Probability of Missile Generation from Low Pressure Turbines

Non-Proprietary Version

June 2013

Figure 2.1-1 Typical Integral Rotor Material Test Locations

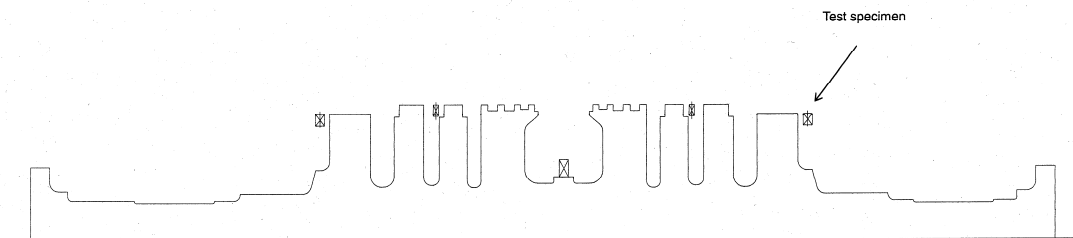
Revision	Page	Description
	2.1-1	<p>The second paragraph is modified as follows.</p> <p><u>“The specification for the integral rotors requires testing at the locations shown in Figure 2.1-1 to confirm uniformity of the rotor.– Using these specimens, the tensile test (tensile strength, yield strength, elongation and area reduction) and Charpy test (Charpy V-notch energy, 50% FATT and upper shelf energy) will impact test (absorbed energy, 50% FATT and upper shelf energy) shall be performed to and confirm that if the required K_{IC} of [] and the other mechanical properties used in this report specifications are satisfied.”</u></p>
